MEMORANDUM

DATE: April 8, 2013

SUBJECT: ZC 12-18 - Final Report: Consolidated PUD and related Map Amendment from the R-4 to R-5-B and HS/C-2-B districts for specified lots in Square 858: 600 Block of H Street, N.E.

Site Plan – Ground Floor (Initial Design)

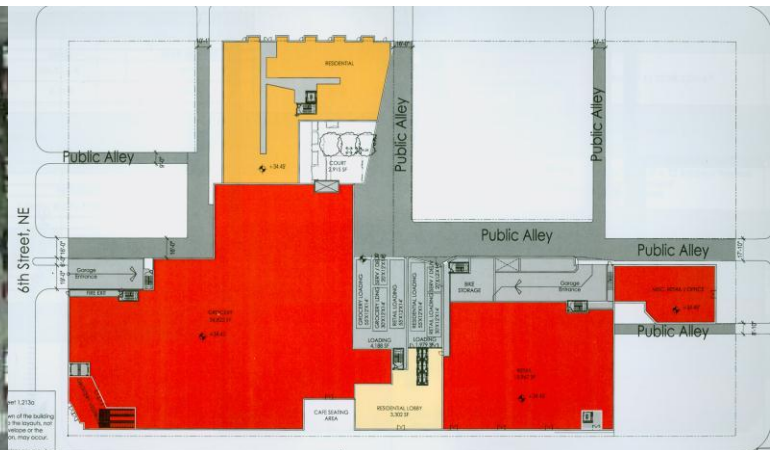
- 96,548 square feet (total) of ground floor retail space;
- Underground parking in two levels - 438 spaces with 163 spaces allocated to the grocery;
- There would be a main residential lobby with one residential entrance off H Street.

- Ground floor retail would front H Street and wrap around to I Street. Outdoor seating would be provided for the grocery retail space identified as a café seating area in the plans. (Page 1.203)

- Space allocated for loading would be increased, but would be centrally located with main access from 6th street.

Proposed Alley Closure

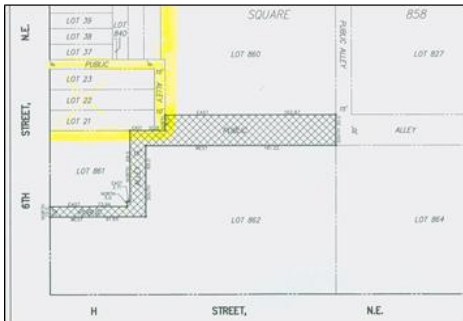
Phase I development includes portions of the existing alley which are proposed to be closed and the remaining alley system reconfigured. As shown in the applicant's diagram below, the existing east-west alley between 6th and 7th Streets would be removed to accommodate the north wing of Phase I. The north-south and east-west

portions of the alley abutting the Murray's parking lot would be removed to accommodate the west wing of Phase I. A new 24-foot wide dedicated public alley easement would connect 6th Street to I Street. It would be widest at 6th Street at 24 feet and emerge at I Street 16 foot in width. However, the alley width of the new north south portion, abutting the residential Lots 21-23 would be at least 22 feet wide. Thus, the reconfigured alley would increase the existing widths to serve existing residents and to provide the required turning radii for vehicles entering the alley to access Phase I's loading and parking areas in the initial design. The alley reconfiguration requires approval by DC Council. Any condition of approval by the ZC would be conditioned on the applicant receiving this approval.

Repositioned curb cut and widened alley

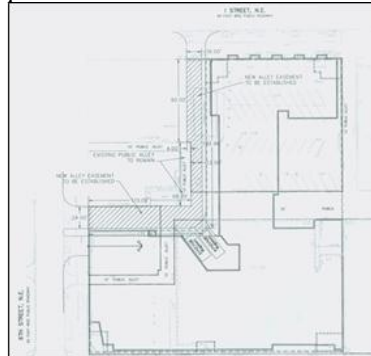
The Applicant requests flexibility in its initial design to provide 4, 30-foot berths rather than the required 55-foot berth based on prior experience within the District that the proposed uses would not require a 55-foot berth. The proposed location of the loading facilities and widening of the alley for both designs would accommodate the project's loading requirements, including the turning radii for delivery trucks and other service vehicles. The grocery alternative would satisfy the main requirements for the loading berths and platforms but would require flexibility to provide one less delivery space at 20 feet for the retail component, which would be shared with the proposed grocery delivery space. DDOT has indicated its support to OP regarding the loading access, particularly the access off 7th Street. The grocery design is preferred as it would remove all truck movements from 6th Street through the wider alley off 7th Street.
